Clinton Power Station Unit 1  
Docket No. 50-461

Enclosed are copies of the Illinois Power Company (IP) position papers regarding Outstanding Issues #10(c), 10(d) and 10(e) of the Clinton Power Station Safety Evaluation Report (Sections 6.2.4.1, 6.2.2, and 6.4/15.3/respectively). These papers were prepared in response to the NRC Staff's concerns in the CPS-SER regarding various containment leakage testing requirements and the acceptability of the proposed 12% containment Bypass Leakage Fraction.

(10c) Containment Leakage Testing (Vent & Purge Valves)

FIGURE 1

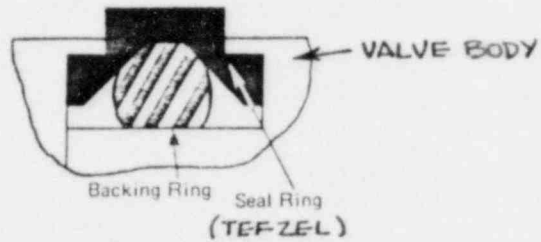
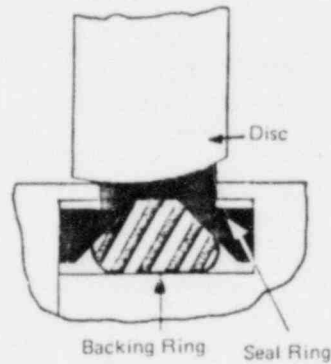
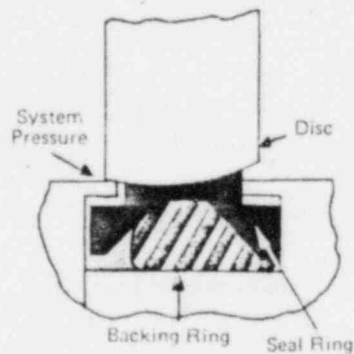
"As a result of numerous reports on the unsatisfactory performance of resilient seats in butterfly-type isolation valves because of seal deterioration, periodic leakage integrity tests of the 4-in. and 36-in. butterfly isolation valves in the purge system are necessary. Therefore, the applicant should propose a technical specification for testing the valves in accordance with the following testing frequency:

The leakage integrity tests of the isolation valves in the containment purge/vent lines shall be conducted at least once every three months for active valves and once every six months for inactive valves."

The 36" Butterfly-type Containment Vent/Purge Isolation valves are manufactured by Posi-Seal International, Inc. The heart of the Posi-Seal valve is the sealing mechanism, which consists of 2 parts. This combination includes a sealing ring and a backing ring. The sealing ring is made of an inert, low-friction, wear-resistant elastomer, called TEFZEL. The I.D. surface of the sealing ring serves to effect a seal against the valve disc, while its flange area securely locks the ring into a "T" slot within the valve body. The backing ring is an "O" ring made from a more resilient elastomer, typically BUNA-N or VITON. When the valve is closed, the backing ring preloads the sealing ring against the valve disc, which affords a static seal. System pressure acting within the "T" slot creates a piston action of the sealing ring, where system pressure is amplified at the sealing surface. Thus, dynamic sealing is accomplished. Hence, the higher the containment pressure, the tighter the seal. A simplified drawing illustrating this sealing design is provided in Figure 1.
